PERMIT 01-158201

SEWAGE DISPOSAL SYSTEM

A Repair

SUBDIVISION ROAD 6109 Hunt Club Road LOT

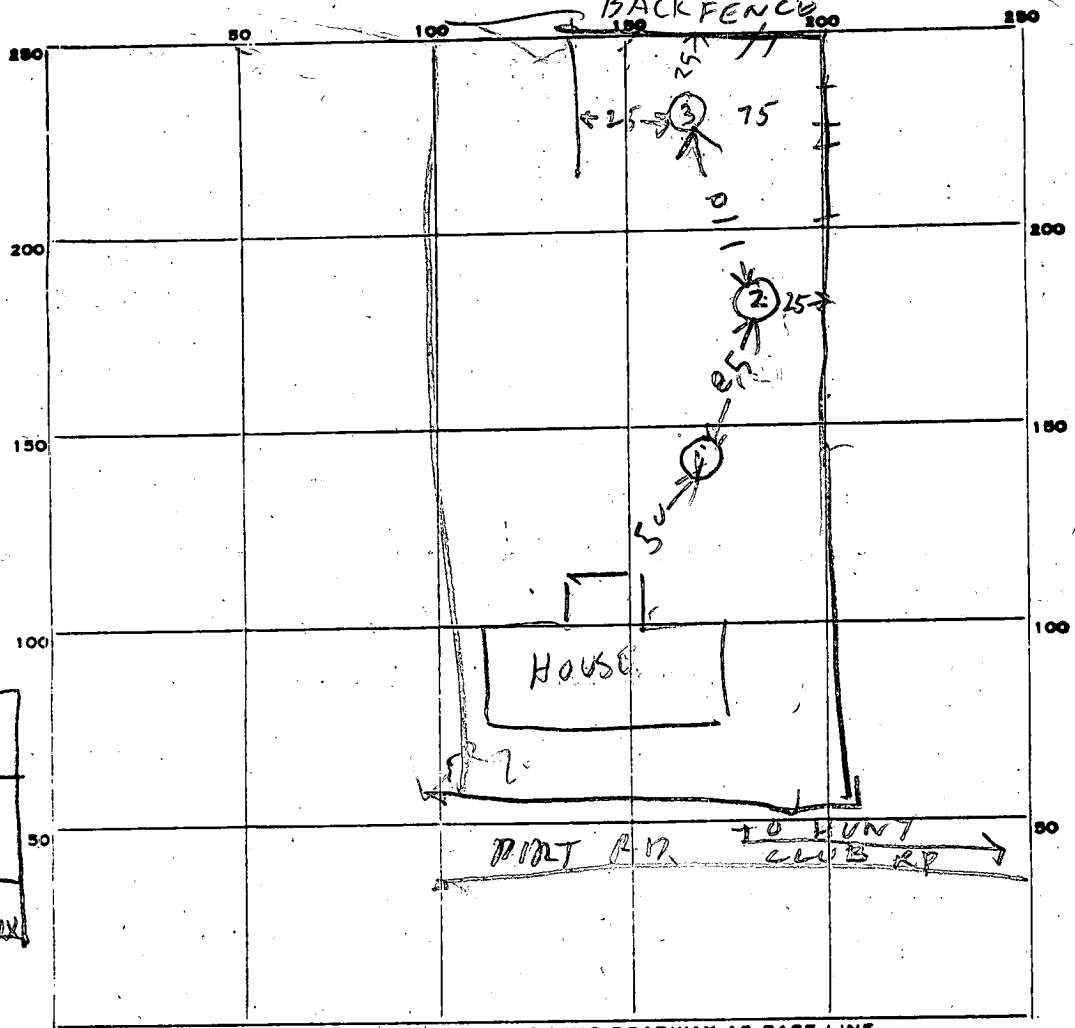
REPAIR - Call for an appointment when ground is opened up and Sanitarian will

recommend the repair system. → 8/26/82 1,500 gallon sealed tank with alarm

device and a maintenance contract with a licesensed scavenger, 7.6,

9/20/82 O.K. to dig up top of old tank to see if it is water tight & properly sealed to be used as a sealed tank 7.5.

REMARKS 9/11/02 3 VISUAL HOLES & ALL CLAY & BACKHOE BROKE ON ③
SEALED TANK ONLY SOLATION NOW RH
